State Water Resources Control Board

August 23, 2021

MERCED GROUNDWATER SUSTAINABILITY PLAN, GROUNDWATER SUBBASIN NO. 5-022.04

The State Water Resources Control Board (State Water Board) staff are providing these comments in support of the Department of Water Resources' (DWR) review of the Groundwater Sustainability Plan (GSP) for the Merced Groundwater Subbasin (subbasin).

Figure 1. 1,2,3-Trichloropropane in Merced Subbasin wells

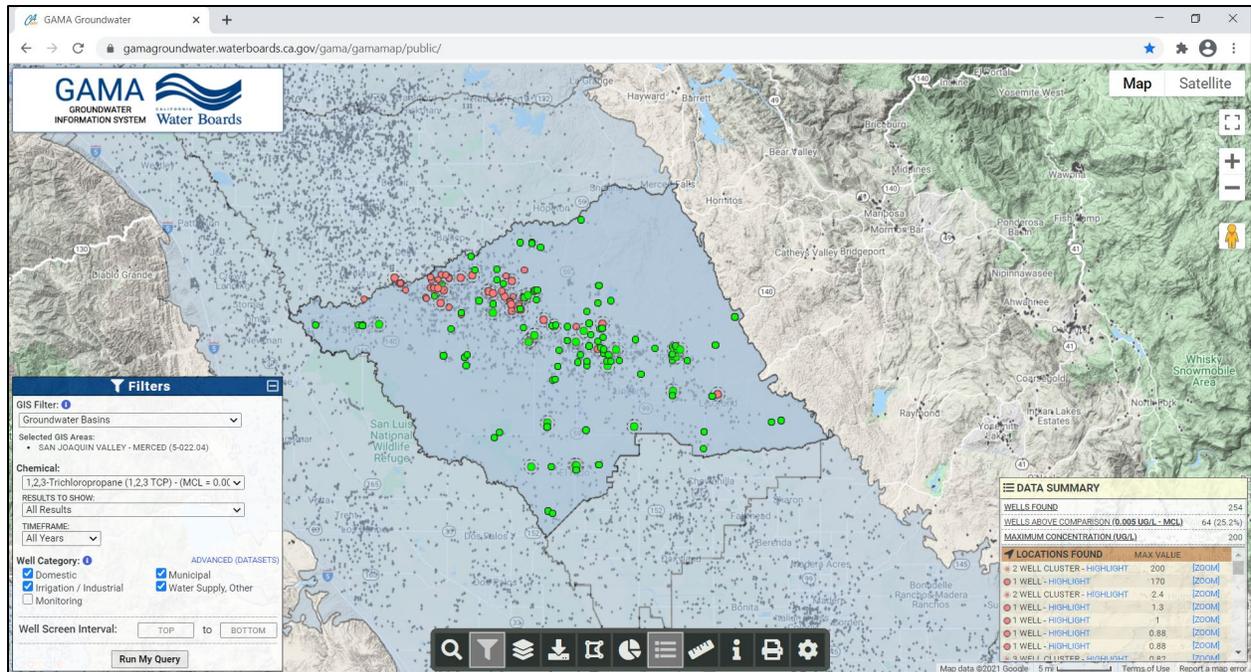
4. The GSP includes monitoring of a many groundwater quality constituents, but only defines SMC for salinity (as total dissolved solids). The GSP states that the “causal nexus between salinity and groundwater management activities has been established” (p. 3-12) but implies this nexus has not been established for other constituents. The GSP states that high salinity groundwater has been shown to migrate both from upwelling of deeper saline brines and across the subbasin due to groundwater pumping. However, groundwater pumping and projects and management actions under the GSAs’ authority may also have the potential to influence groundwater concentrations and distributions of widespread contaminants within the subbasin in addition to salinity. Based on their prevalence within the subbasin, GSP implementation should also include SMC for 1,2,3-trichloropropane (1,2,3-TCP), nitrate as nitrogen (nitrate), and arsenic. Staff have attached maps from the [State Water Board Groundwater Ambient Monitoring and Assessment \(GAMA\) Program’s database](https://gamagroundwater.waterboards.ca.gov/) (<https://gamagroundwater.waterboards.ca.gov/>) showing 1,2,3-TCP, nitrate, and arsenic impacts in subbasin groundwater (Figures 1, 2, and 3 in Appendix).
